**Zoning Board of Appeals  
June 25, 2014 Regular Meeting**

**STAFF REPORT**

**Subject: ZBA14-006, 207 E. Kingsley**

**SOUTH ELEVATION**  
5/16" = 1'-0"

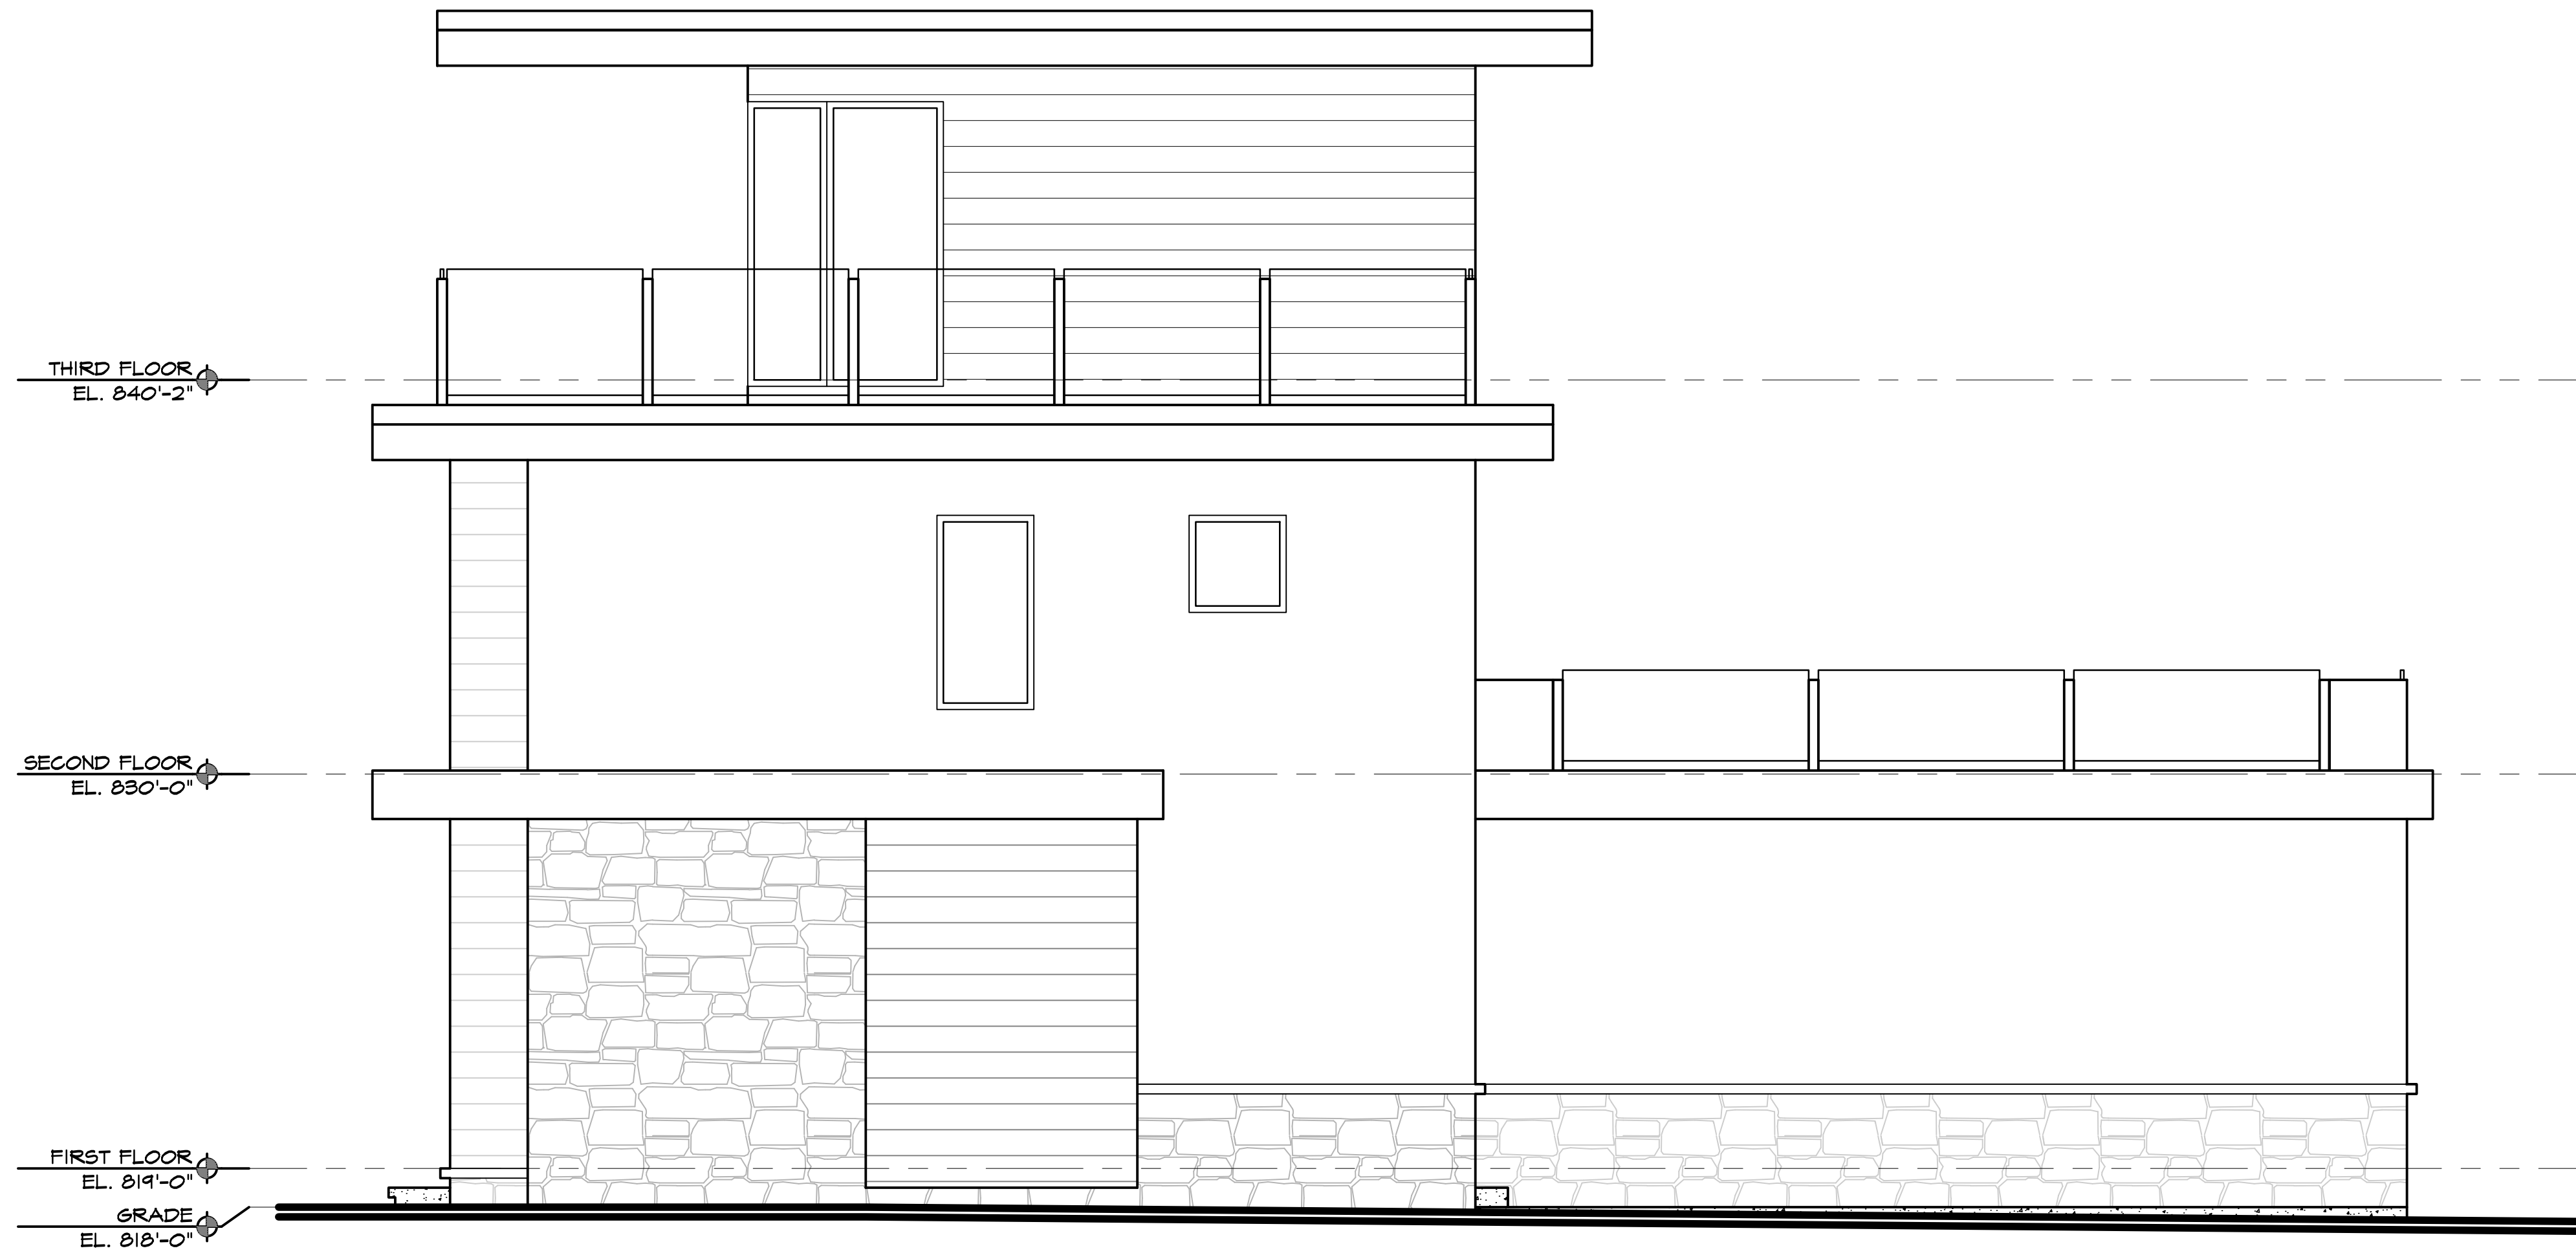
**June 25, 2014 Staff Correction:** Requested variance is actually 1 foot 7 inches and not 2 feet as stated in original report. Staff had originally used the highest point of the structure for the maximum height determination, however Chapter 55 (Zoning) defines building height using the average elevation and not the maximum height at any one point. See revised report below for more information.

According to Chapter 55 (Zoning), building height is defined as, “*The vertical distance of a building measured from the average elevation of the finished grade within 20 feet of the building to the highest point of the roof for a flat roof, to the deck line of a mansard roof, or to the midpoint elevation between eaves and ridge for a gable, hip or gambrel roof of a building.*” The maximum height in the R4C district is 30 feet. The proposed building will have a flat roof with a maximum height of 32 feet 4 inches and a minimum height of 30 feet 10 inches due to the slight slope of the land. Calculating the height of the building from the average elevations, as noted above, results in a building height of 31 feet 7 inches. As such, a variance is required to exceed the 30 foot height limit. If the building had a gabled roof or peak, the maximum height of the peak could exceed 30 feet as long as the midpoint of the peak was 30 feet or less.

KINGSLEY ST.  
STREET SCAPE LOOKING EAST

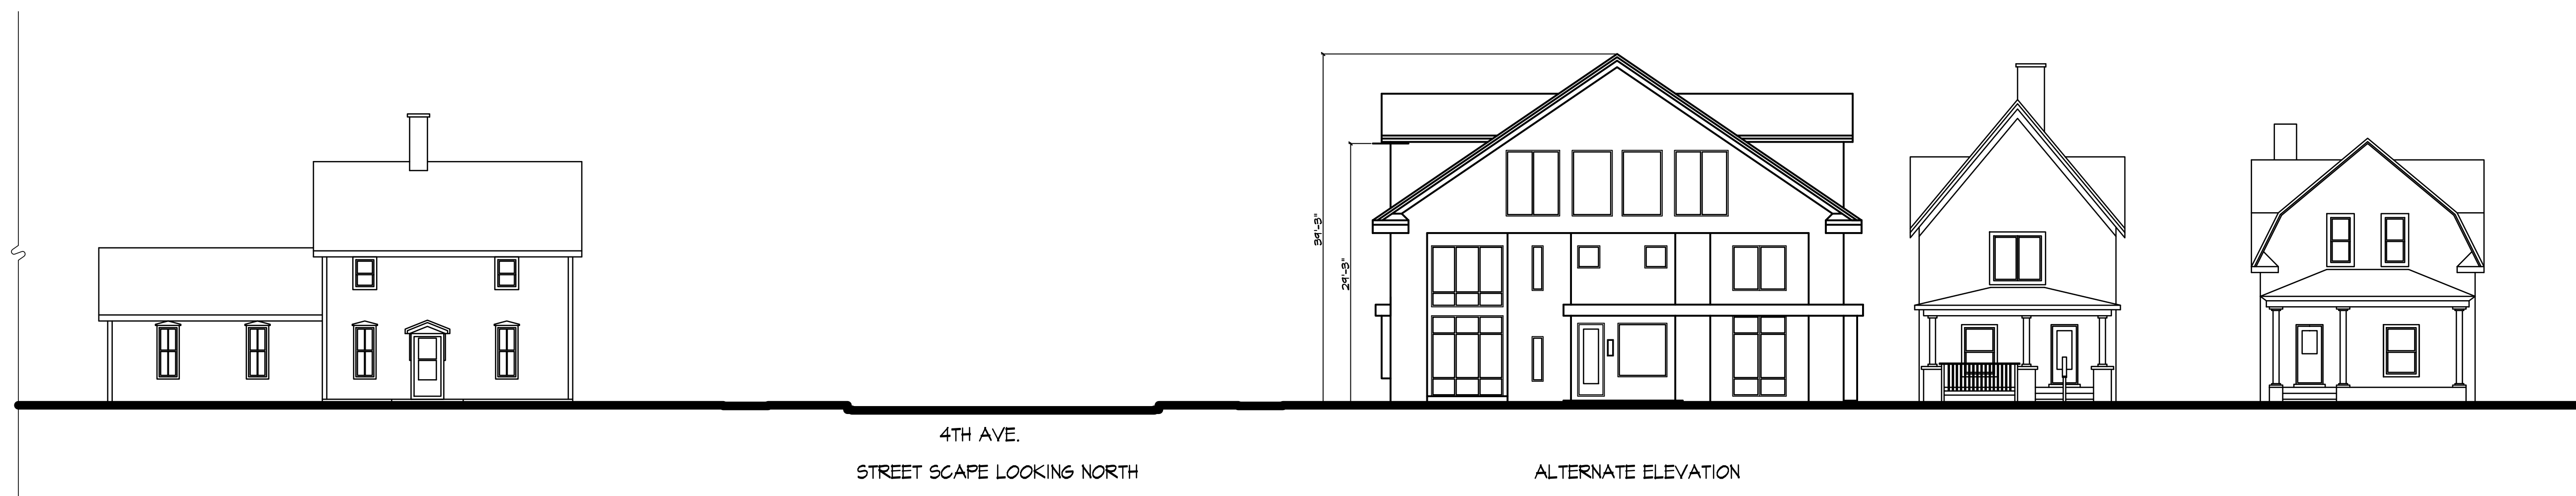
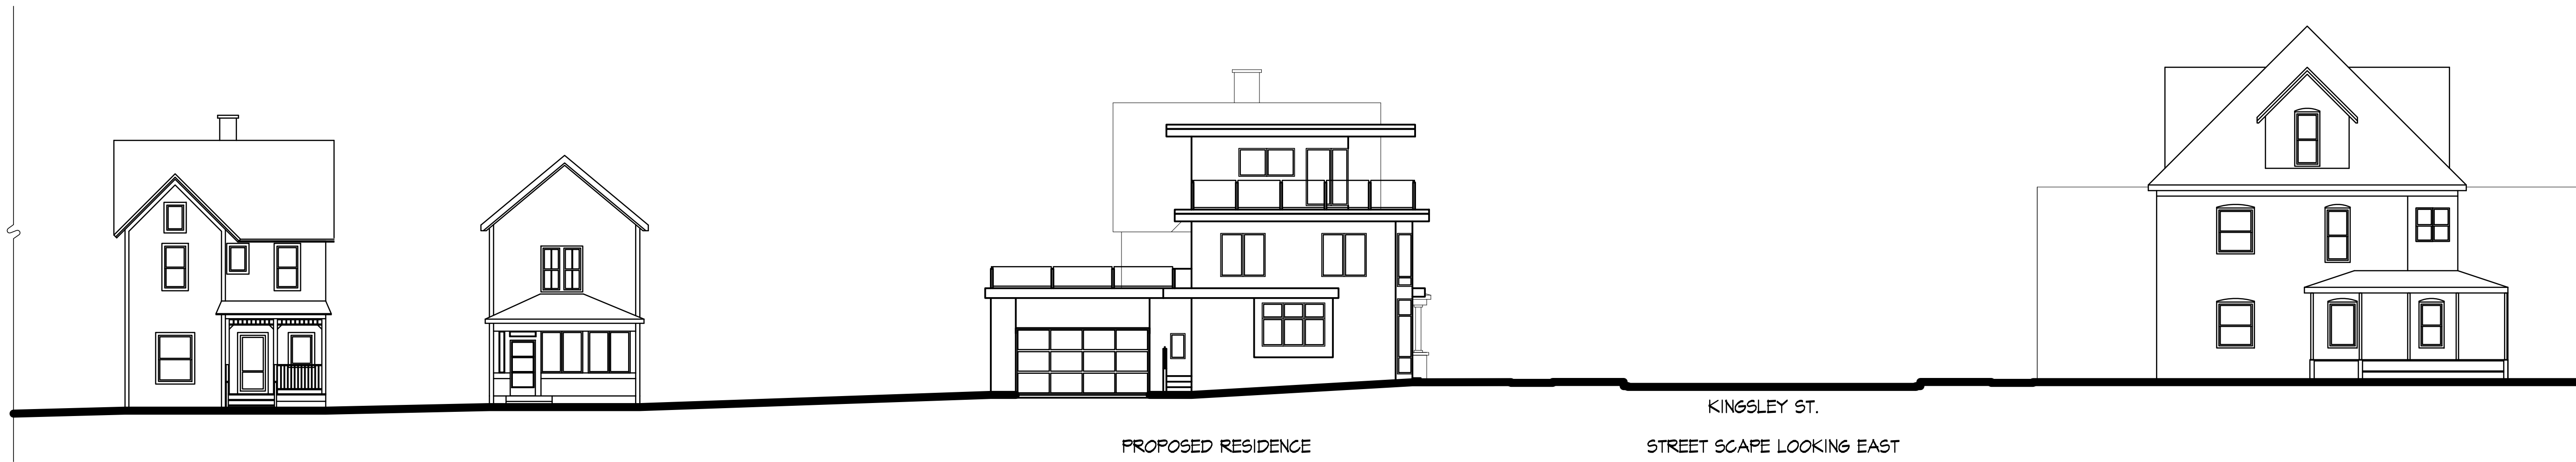
The petitioners argue that the proposed roof would be no higher than the midpoint of a pitched roof that would be comply with the 32 foot height limit. The street renderings, however, graphically demonstrate the contrast between the two designs. While either would be much larger than its neighbors, the pitched roof design is far less dominant.
